Comment Resolution related to 4x4 MIMO Practicality (CID 69)

IEEE P802.22 Wireless RANs

Date: 2014-03-06

Comment Resolution (CID 69)

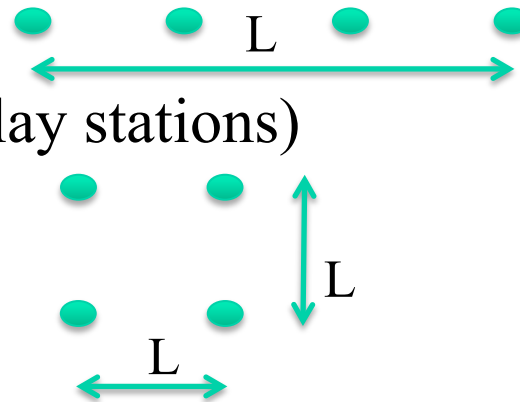
ID	Comment	Suggested Remedy
69	Due to the physical size of the antennas in the VHF and UHF TV broadcast bands, the use of 4 x 4 MIMO will very likely be limited.	Consider the added complexity to the proposed standard and the probability of use of such technology in practice.

- 4x4 ULA (10λ BS, High relay)

- $L = 15$ meters

- 4x4 URA (10λ BS, High relay)

- $L = 5$ meters

- As stated in [1], 4λ (2 meters) is however capable of achieving 80% of the throughput as compared to 10λ separation.
